Planning & Development Division
Planning & Economic Development Department

File Number	PLPR-2505-0002		Contact	Jason Mozol, jmozol@duluthmn.gov	
Type	MU-I Planning Review		Planning Commission Date		June 10, 2025
Deadline for Action	Application Date		May 23, 2025	60 Days	July 22, 2025
	Date Extension Letter Mailed		May 27, 2025	120 Days	September 20, 2025
Location of Subject		2030 N Arlington Ave			
Applicant	St Louis County		Contact	Scott Hudson	
Agent	Widseth		Contact	Ryan Erspamer	
Legal Description		010-2710-03940			
Site Visit Date		May 29, 2025	Sign Notice Date		May 25, 2025
Neighbor Letter Date		May 23, 2025	Number of Letters Sent		93

The applicant is proposing a ~12,000 square foot cold storage building at 2030 N Arlington Ave in an MU-I district.

1. THE SUBSURFACE UTILITY INFORMATION IN THIS PLAN IS UTILITY QUALITY LEVEL D, THIS QUALITY LEVEL WAS DETERMINED ACCORDING TO THE GUIDELINES OF CI/ASCE 38.2, ENTITLED "STANDARD GUIDELINES FOR THE COLLECTION AND DEPICTION OF EXISTING SUBSURFACE UTILITY DATA".

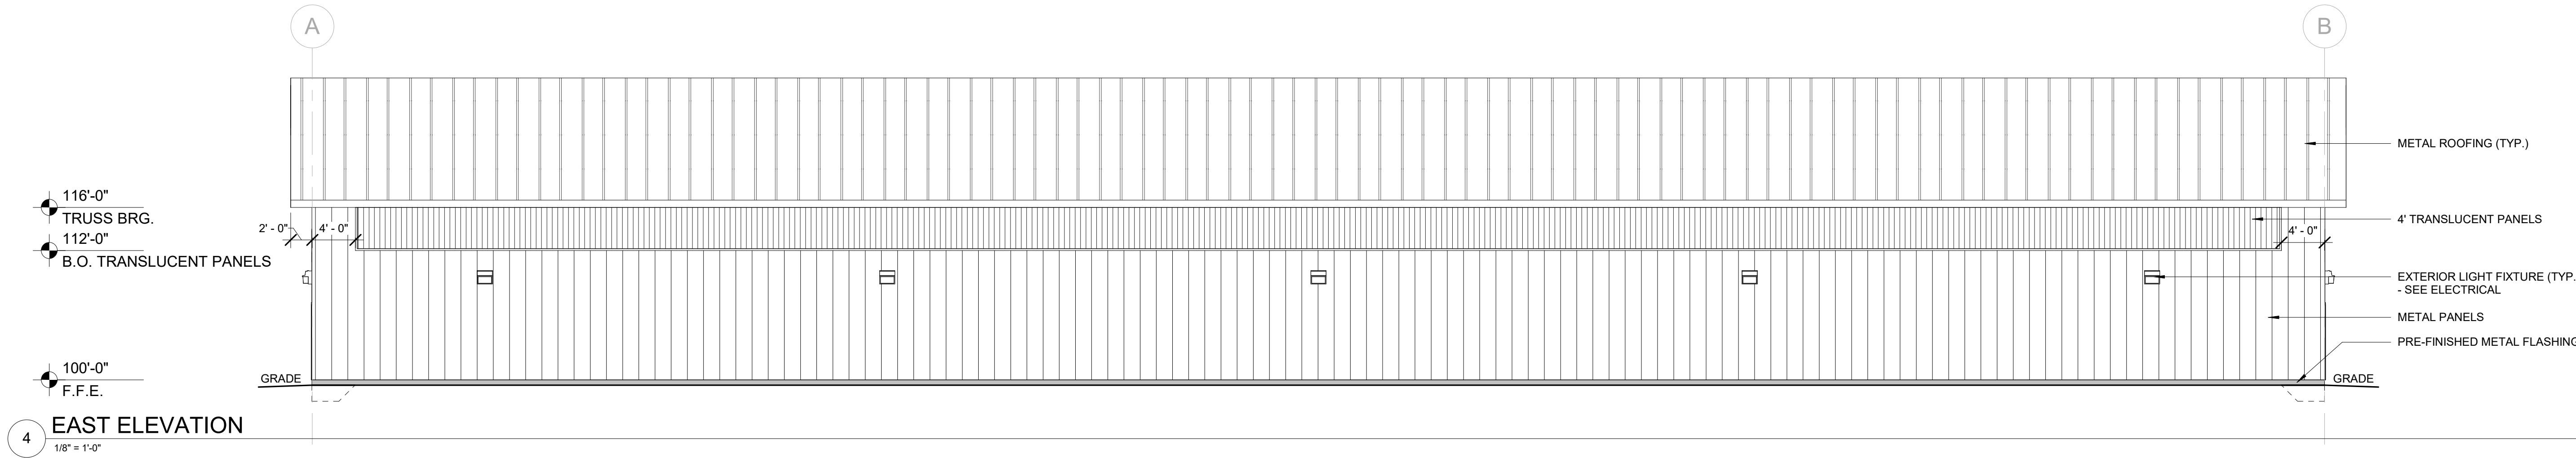
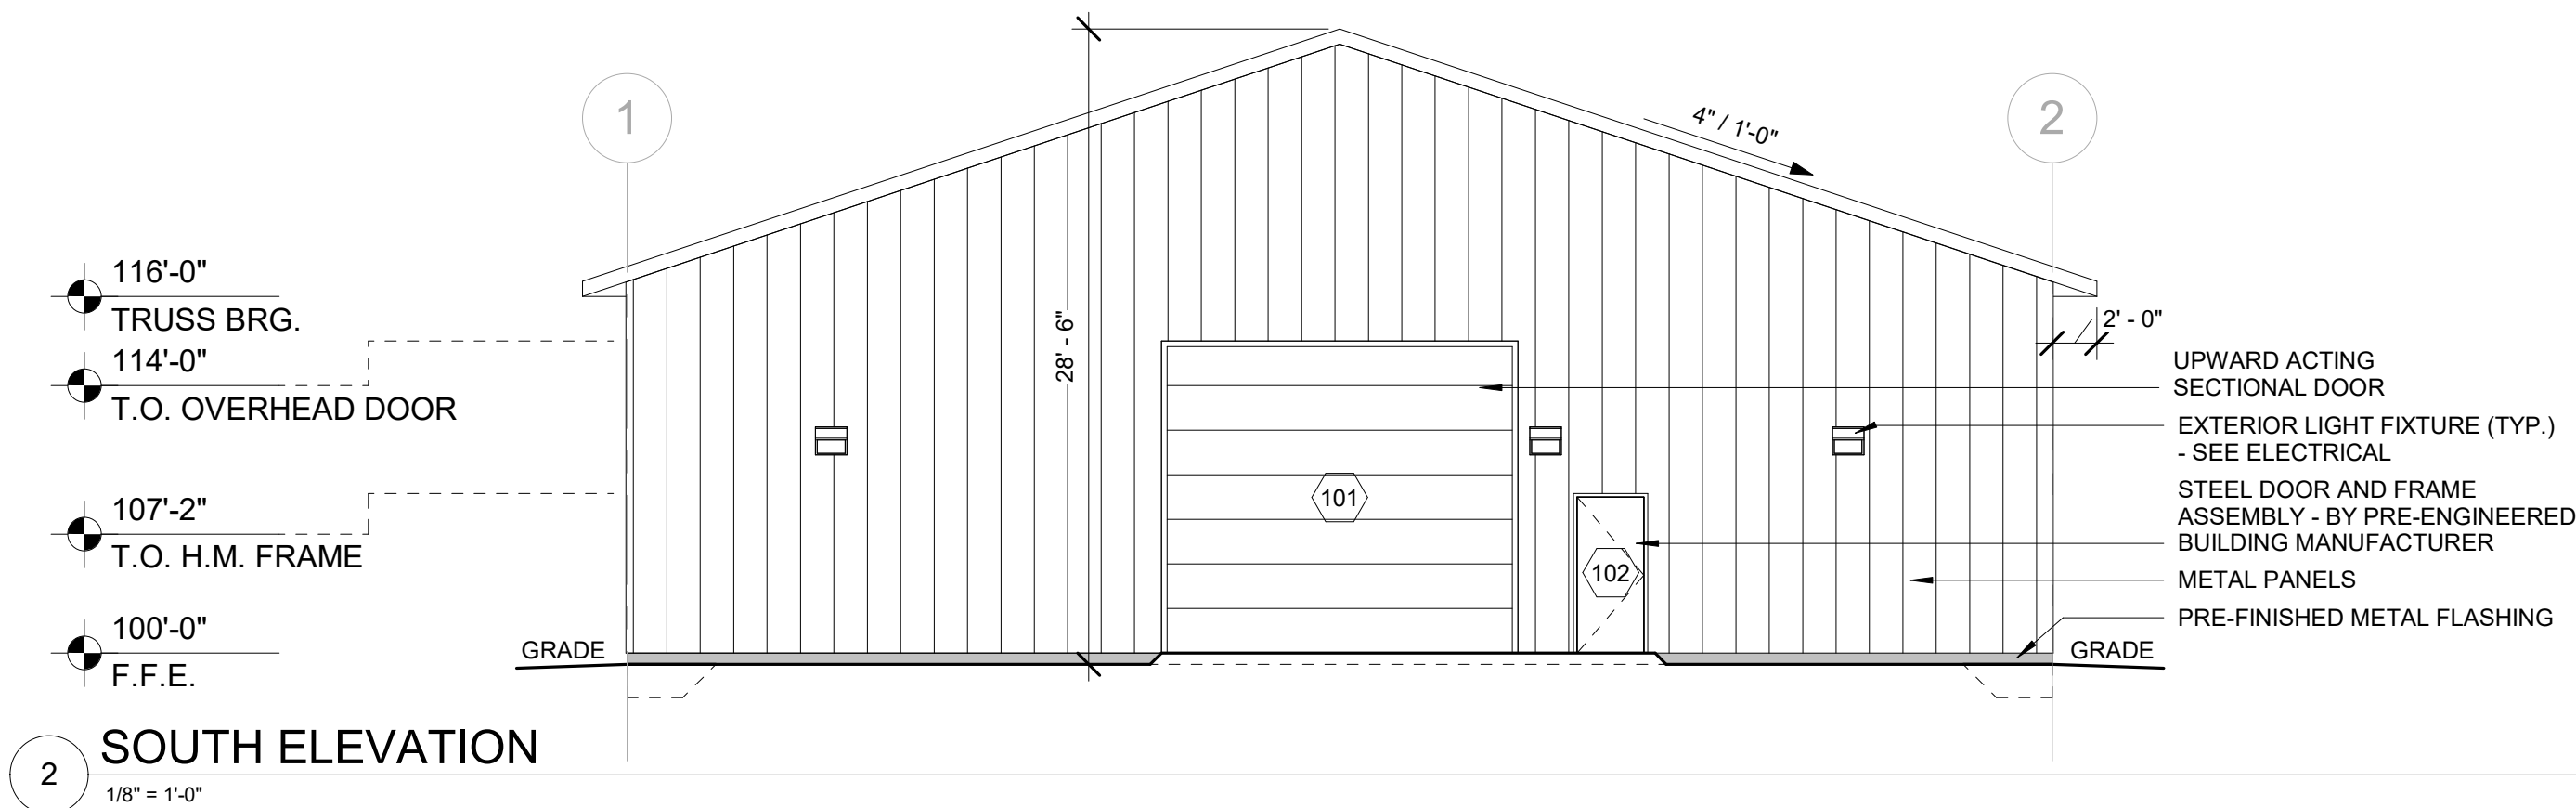
8. Sec. 50-31 (Exterior Lighting). Exterior lights will be installed on the outside of the structure. The applicant provided a photometric plan and light fixture designs. The proposed lighting exceeds the maximum illumination of 10 footcandles and the proposed fixtures do not meet the downcast or cutoff requirements. A compliant lighting plan must be submitted to the Land Use Supervisor prior to building permit approval.

1. Applicant shall construct and maintain the project as identified in the attached exhibits.
2. An amended, compliant lighting plan be submitted and approved by the Land Use Supervisor prior to building permit approval.
3. Any alterations to the approved plans that do not alter major elements of the plan may be approved by the Land Use Supervisor without further Planning Commission approval; however, no such administrative approval shall constitute a variance from the provisions of Chapter 50.
